STAGE 4

Archer Humphryes Architects

project title	
KOKO + Hope & Anchor + Bayham Place Camden, London	
drawing title	scale date
Proposed First Floor Plan	1:100 A1 13.04.17
drawing number	drawn checked
AHA/KKG/GA/101	FR/PC DA
	revision
	D

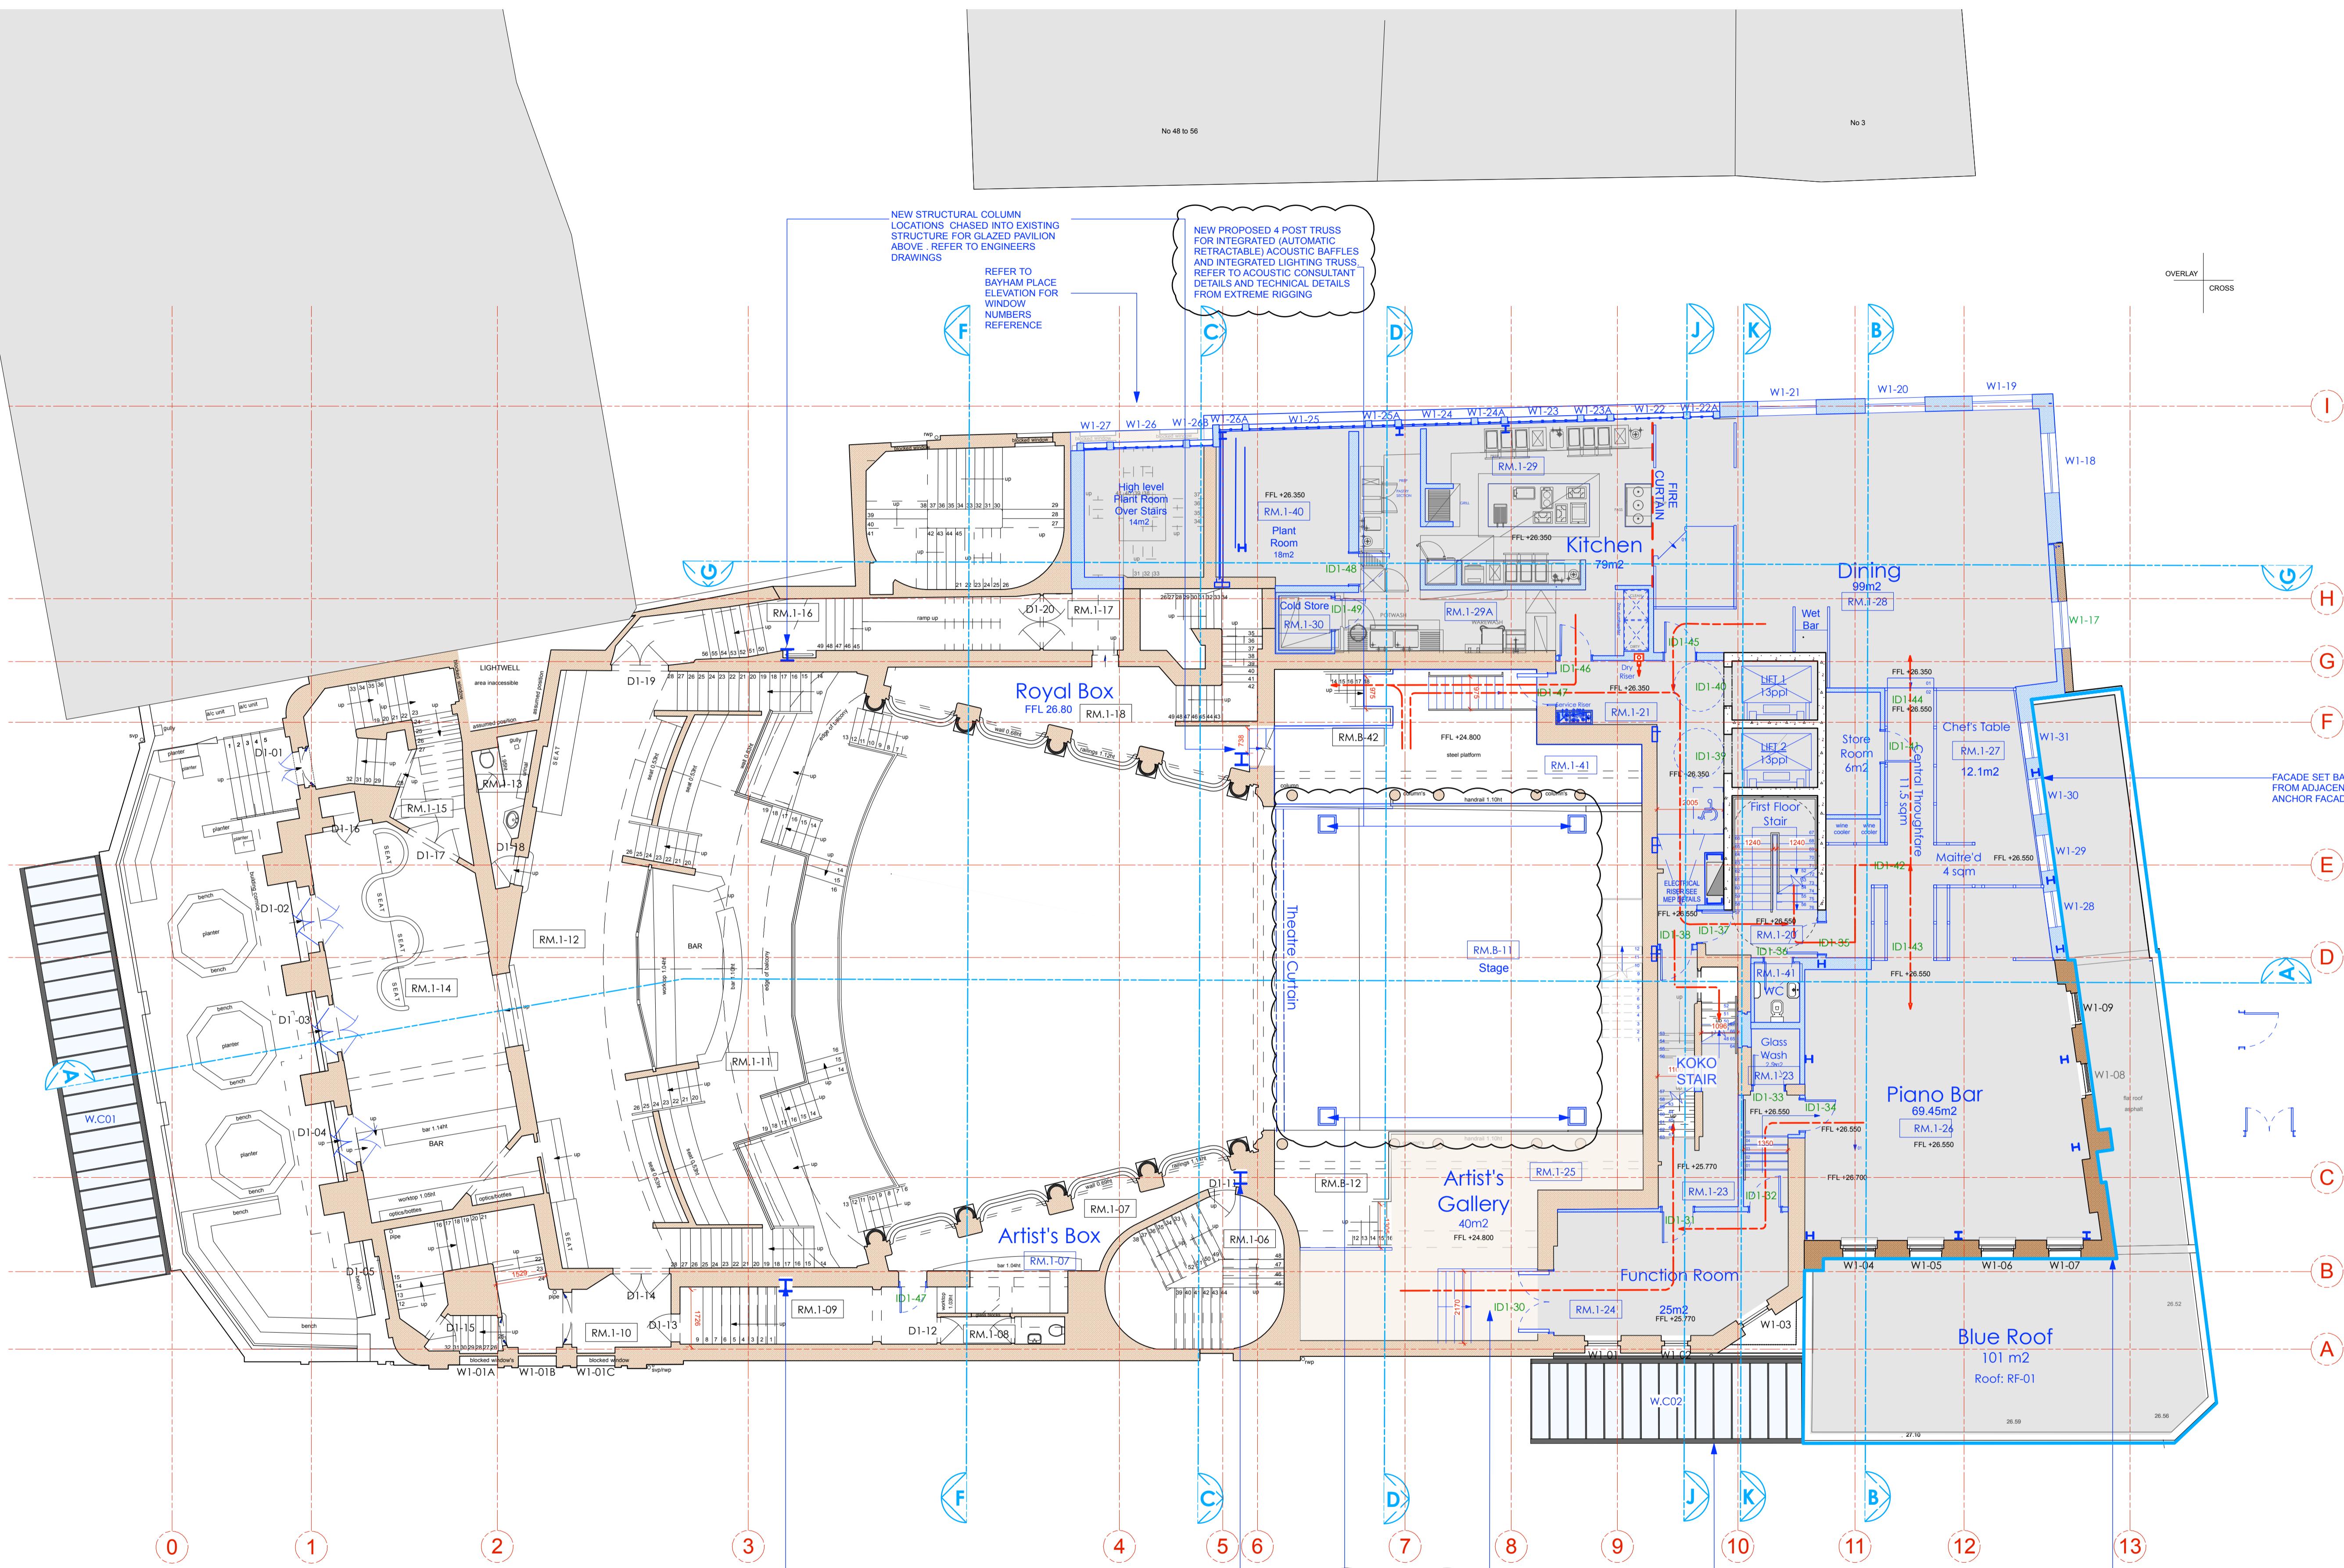
revision / date / amendments	
- / 26/01/18	- First Issue
A / 01/03/18	- Window numbers updated in line with Window schedule.
B / 23/03/18	1. Tender Addendum [1], Indication of 4 post truss fixed at stage level for integrated automatic retractable acoustic baffles and integrated lighting rig. 2. Tender Addendum [2], New AHU + Attenuator over stage to be hung to existing relocated secondary beams in Flytower.
C / 12/04/18	- Window and Door number updated Listed Building Application
D / 01/06/18	1. Indication of 4 post truss fixed at stage level for integrated automatic retractable acoustic baffles and integrated lighting rig. 2. New AHU + Attenuator over stage to be hung to existing relocated secondary beams in Flytower.
